Re: **Joliet Junior College, Illinois Community College District No. 525
Master Facilities Plan Phase 2, Automotive Building Expansion Work Bid Release 17
1215 Houbolt Road, Joliet, Illinois 60431**

Subject: **Supplement No. 2**

DIVISION 0 – REVISIONS, CLARIFICATIONS, AND MODIFICATIONS
SECTION 009113 – ADDENDUM 1

Subject: **Addendum No. 1 to the Bid Documents for:
Joliet Junior College - Automotive Service Technology Expansion
1215 Houbolt Road
Joliet, IL 60431**

C4.00

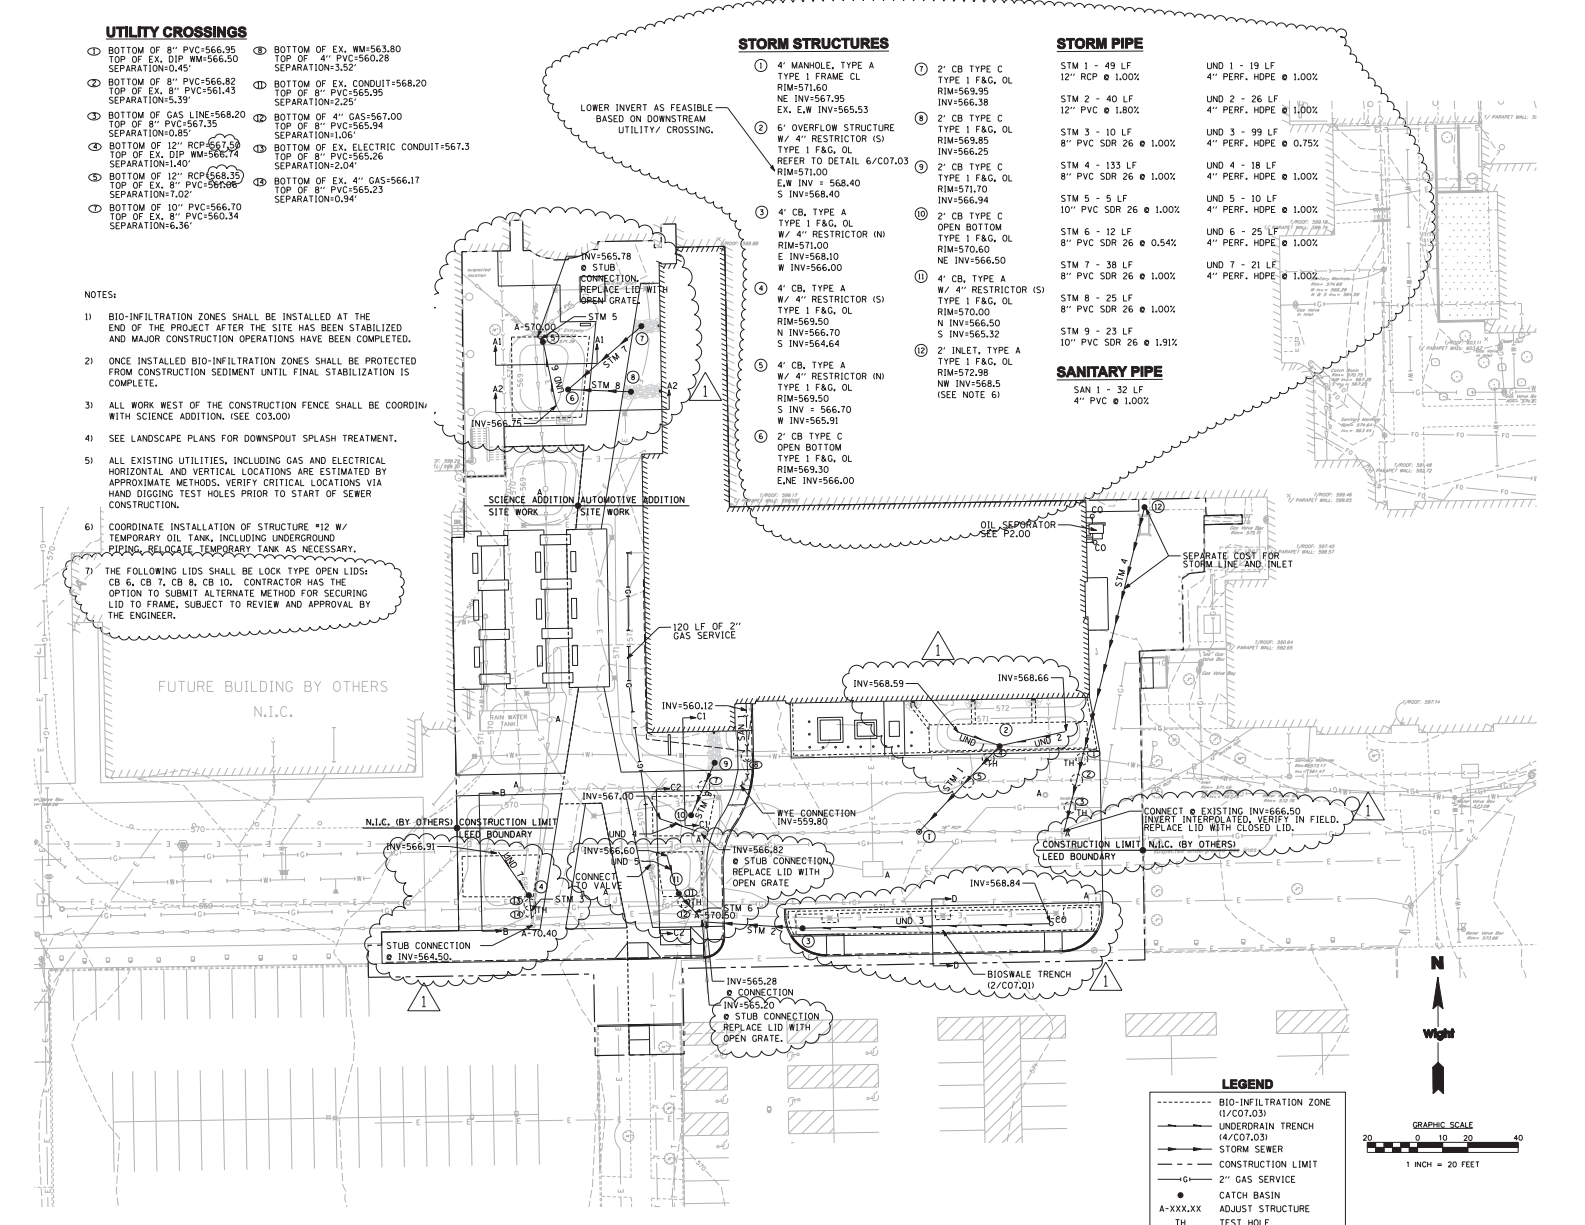
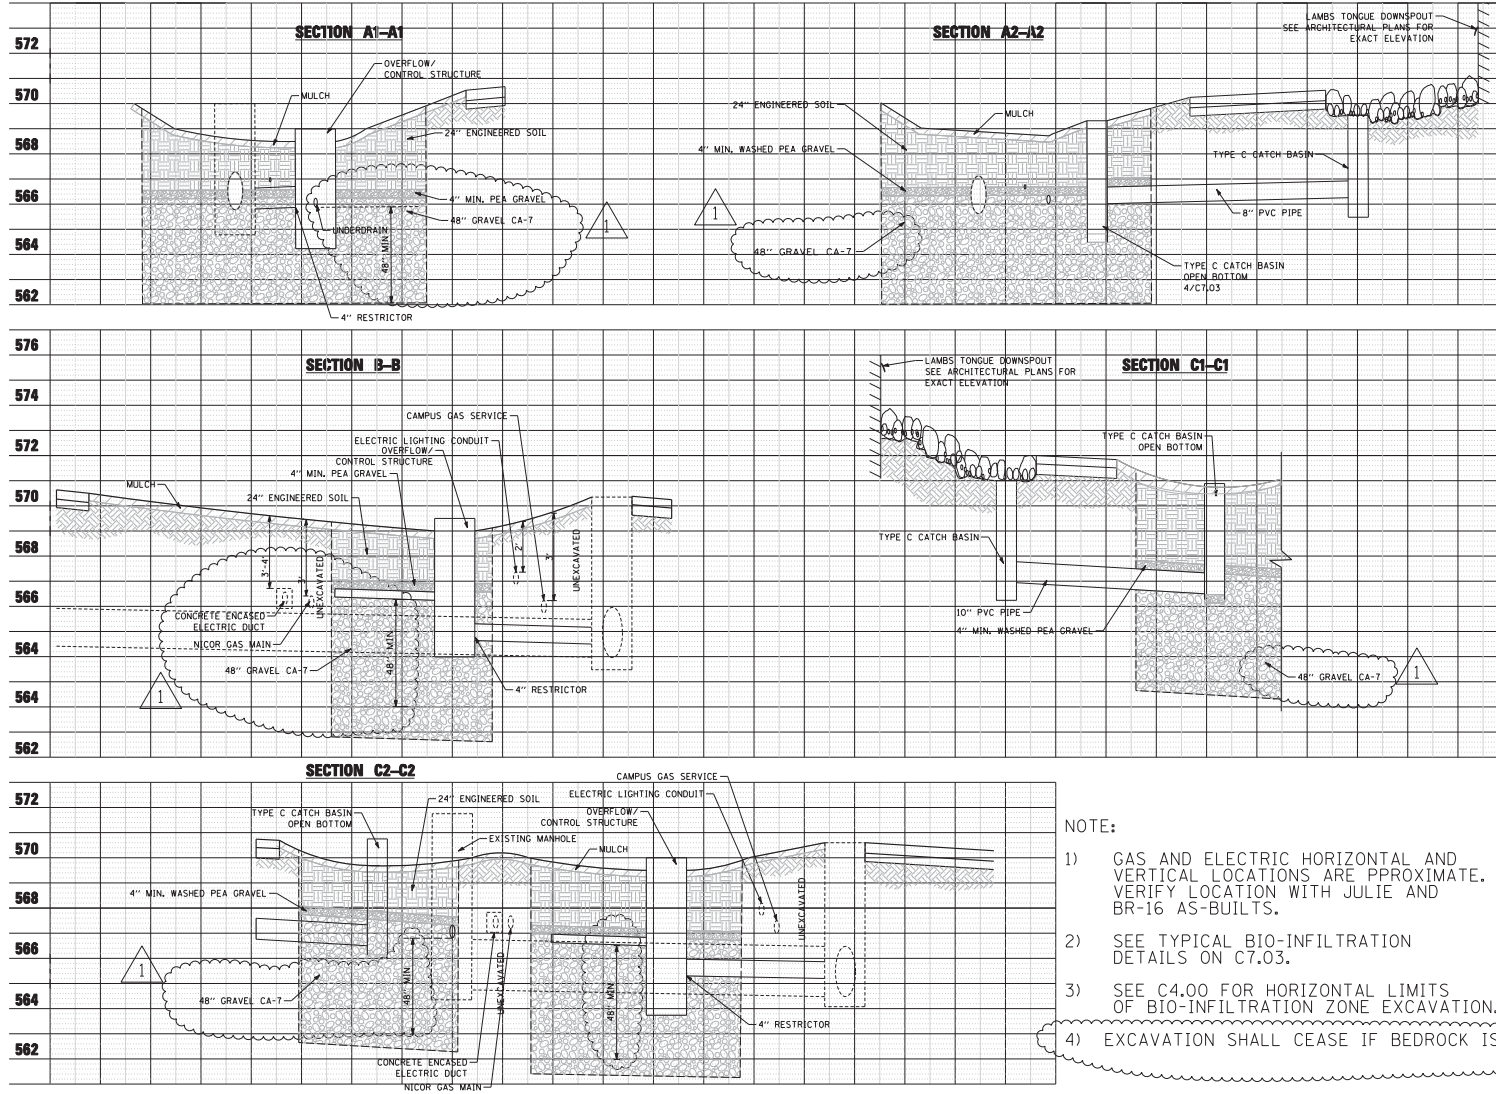
22. Drawing C04.00: Note the following modifications and refer to revised full size sheet attached:
 - a. Revise rims elevation of structures 4, 5, 6, 7, 8, 9, 11.

- b. Replace lids of selected existing structures with open lids.
 - c. Replace lids of selected proposed structures with open lids.
 - d. Revise underdrain pipe length.

- e. Revise storm pipe lengths.
 - f. Revise the location of structures 2, 4, 5, 11.
 - g. Revise the invert of the underdrain pipes.
 - h. Note adjustment elevation of selected existing structure.

- i. Note pipe stubs to be provided by others out of existing structures near structures 11, 10, 4, 5.
 - j. Structure 6 revised to 6' diameter CB structure with restrictor and overflow weir.

- k. STM 1 revised to 1% slope.
 - l. Note requirement for lock type lids on structures 6, 7, 8, and 10.
23. Drawing C04.01: Note the following modifications and refer to revised full size sheet attached:

- 6) COORDINATE INSTALLATION OF STRUCTURE #12 W/ TEMPORARY OIL TANK, INCLUDING UNDERGROUND PIPING, RELOCATE TEMPORARY TANK AS NECESSARY.
- 7) THE FOLLOWING LIDS SHALL BE LOCK TYPE OPEN LIDS: CB 6, CB 7, CB 8, CB 10. CONTRACTOR HAS THE OPTION TO SUBMIT ALTERNATE METHOD FOR SECURING LID TO FRAME. SUBJECT TO REVIEW AND APPROVAL BY THE ENGINEER.

C4.01

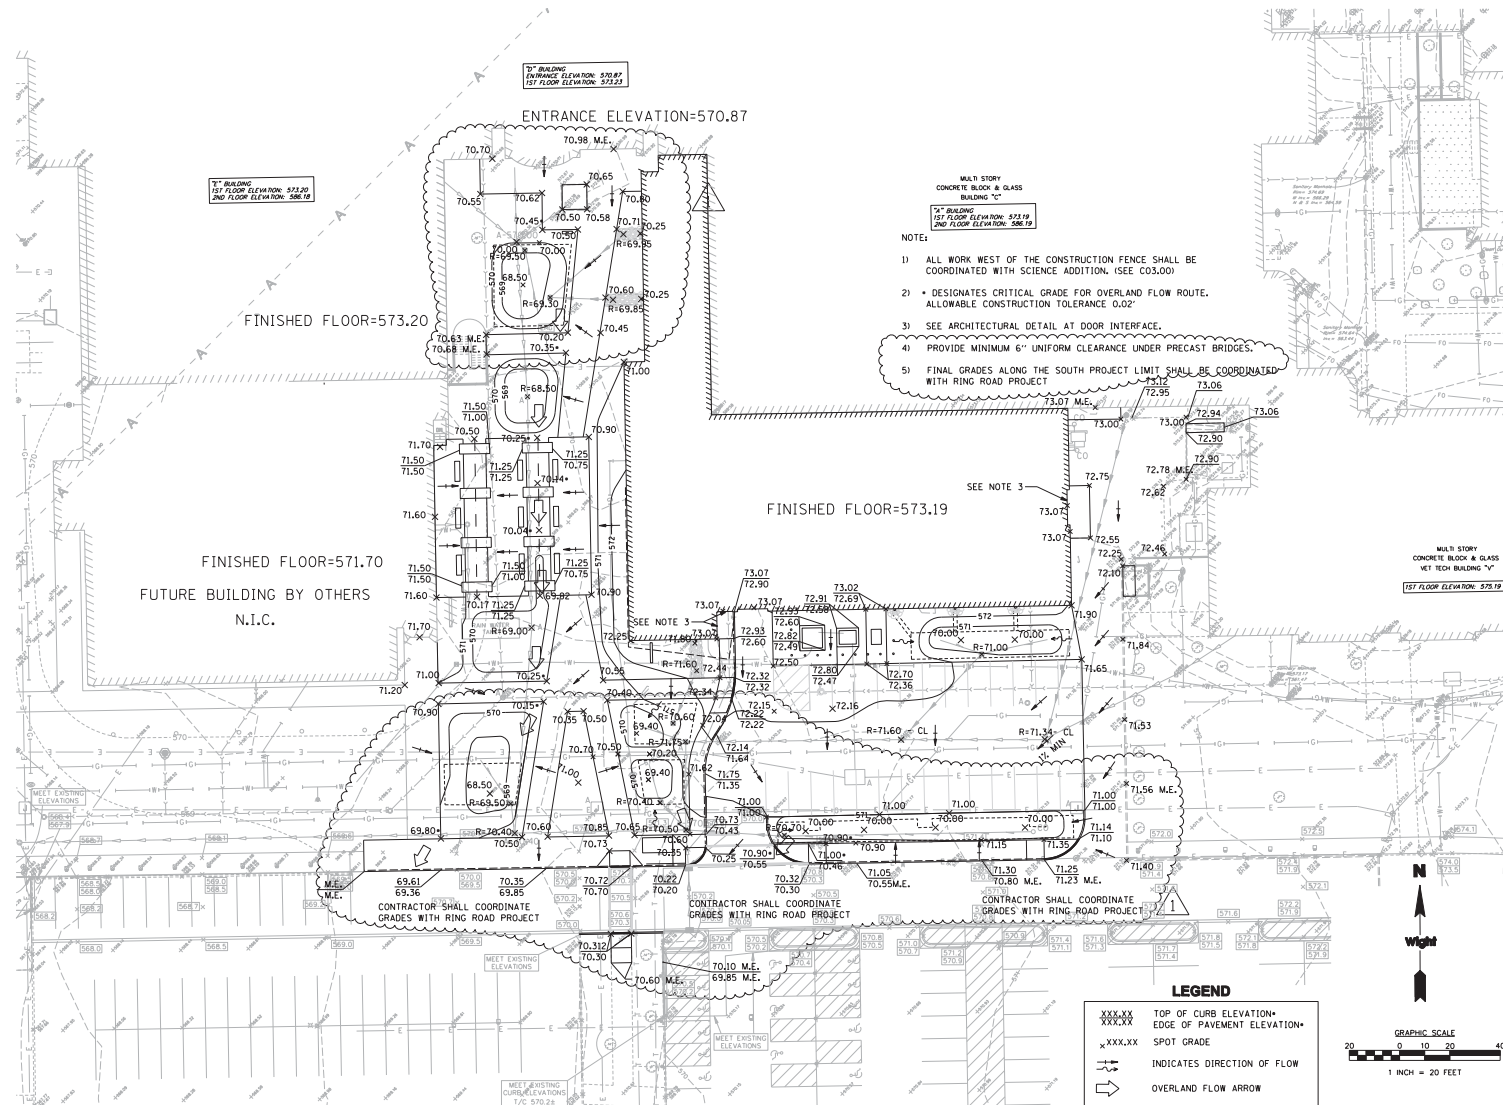
- a. Revise CA-7 depth to 48."
 - b. Add notes regarding bed rock excavation shall not be required for bio-infiltration zone construction.
24. Drawing C05.00: Note the following modifications and refer to revised full size sheet attached:

- NOTE:
- 1) GAS AND ELECTRIC HORIZONTAL AND VERTICAL LOCATIONS ARE APPROXIMATE. VERIFY LOCATION WITH JULIE AND BR-16 AS-BUILTS.
 - 2) SEE TYPICAL BIO-INFILTRATION DETAILS ON C7.03.
 - 3) SEE C4.00 FOR HORIZONTAL LIMITS OF BIO-INFILTRATION ZONE EXCAVATION.
 - 4) EXCAVATION SHALL CEASE IF BEDROCK IS ENCOUNTERED

C5.00

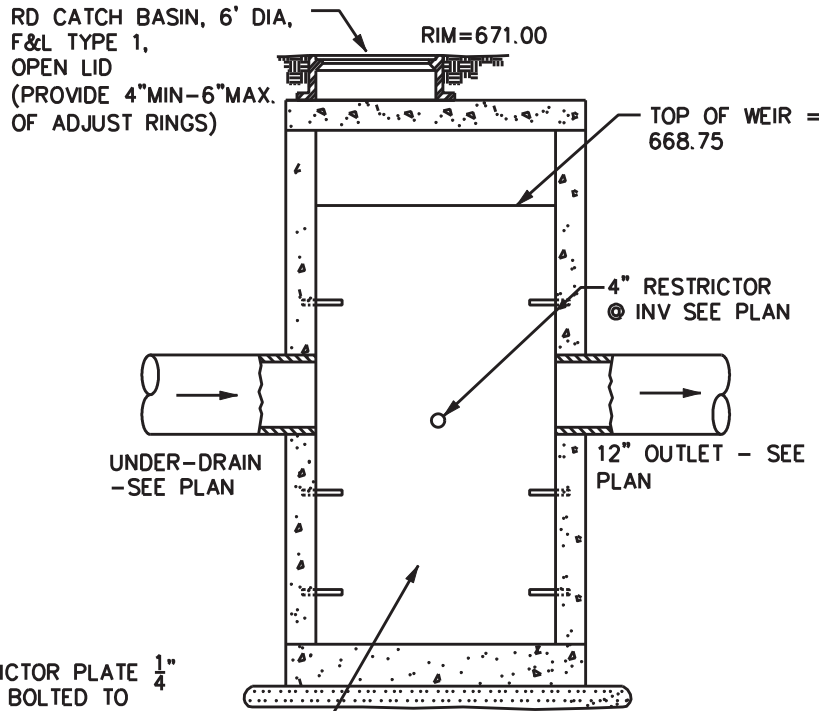
- a. Revise grades.
 - b. Note required coordination with Ring road project.
25. Drawing C06.00, add note " Flat work and curb construction shall be coordinated with adjacent Ring Road construction schedule"

Sketch Number:
CSK-01

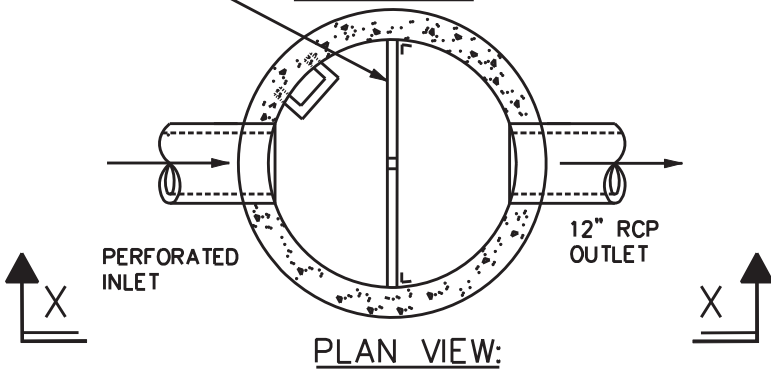
- a. Add "Restrictor Overflow Structure #2" detail per attached sketch CSK-01.
 - b. Revise bio infiltration detail per attached sketch CSK-02.

RESTRICTOR PLATE $\frac{1}{4}$ "
STEEL BOLTED TO
INSIDE OF STRUCTURE
SIDES TO BE CAULKED
WITH WATERPROOF MASTIC

CSK-03

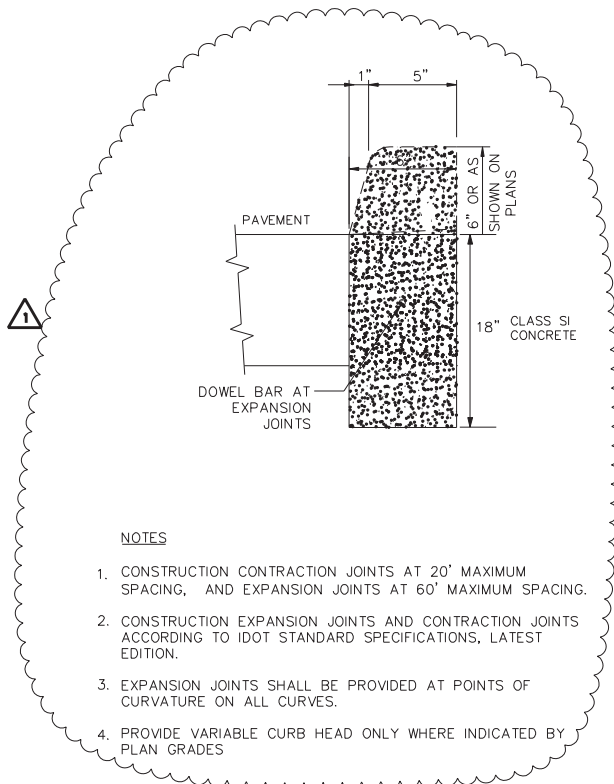
26. Drawing C07.00, revise barrier curb detail per attached sketch CSK-03.
27. Drawing C07.01, revise Bioswale trench detail per attached sketch CSK-04
28. Drawing C07.03:

1. CONSTRUCTION CONTRACTION JOINTS AT 20' MAXIMUM SPACING, AND EXPANSION JOINTS AT 60' MAXIMUM SPACING.
2. CONSTRUCTION EXPANSION JOINTS AND CONTRACTION JOINTS ACCORDING TO IDOT STANDARD SPECIFICATIONS, LATEST EDITION.
3. EXPANSION JOINTS SHALL BE PROVIDED AT POINTS OF CURVATURE ON ALL CURVES.
4. PROVIDE VARIABLE CURB HEAD ONLY WHERE INDICATED BY PLAN GRADES
